- **SUSPENSION—VEHICLE SWAY/LEAN DURING LOW SPEED TURNING MANEUVERS**
- **NOISE—SUSPENSION—POPPING NOISE IN FRONT END**

**Article No.
04-11-2**

FORD: 2001-2004 F-53 MOTORHOME

Figure 1 - Article 04-11-2

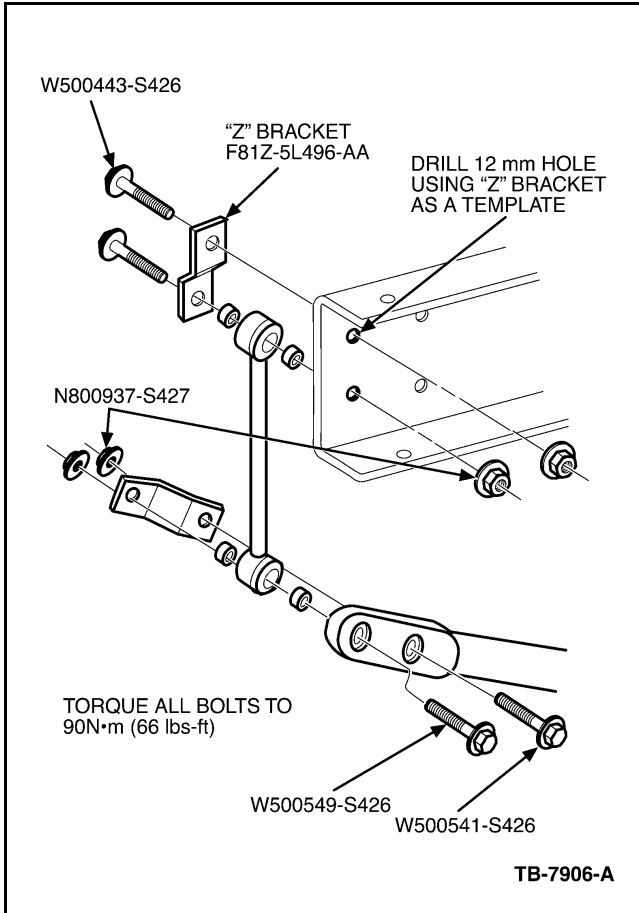
Some 2001-2004 F-53 Motorhome vehicles may exhibit a popping noise and/or sway/lean during low speed turning maneuvers.

Install "Z" brackets to support the attachment of the sway bar links.

1. Remove upper and lower sway bar links per Workshop Manual Section 204-01. Retain the bolts, nuts and spacers for reuse.
2. Install the "Z" bracket F81Z-5L496-AA with the lower sway bar link using new bolt W500549-S426, use original nut and spacers. Install bolt W500541-S426 into the sway bar and "Z" bracket, install nut N800937-S427. Torque both bolts and nuts to 90 N•m (66 lb-ft).
3. Install "Z" bracket with upper sway bar link using original bolt, nut and original spacers. Complete Step 4 prior to final torque.
4. Position "Z" bracket at 90 degrees to the frame rail. Using the "Z" bracket as a template, drill a 12 mm hole into the frame channel and install bolt W500443-S426 through the "Z" bracket and frame. Install nut N800937-S427 and torque both bolts and nuts to 90 N•m (66 lb-ft).

1. Remove only the lower sway bar links per Workshop Manual Section 204-01. Retain nuts and spacers for reuse.
2. Install the "Z" bracket F81Z-5L496-AA with the lower sway bar link using new bolt W500549-S426, use original nut and spacers. Install bolt W500541-S426 into the sway bar and "Z" bracket, install nut N800937-S427. Torque both bolts and nuts to 90 N•m (66 lb-ft).
3. Repeat procedure on opposite side.
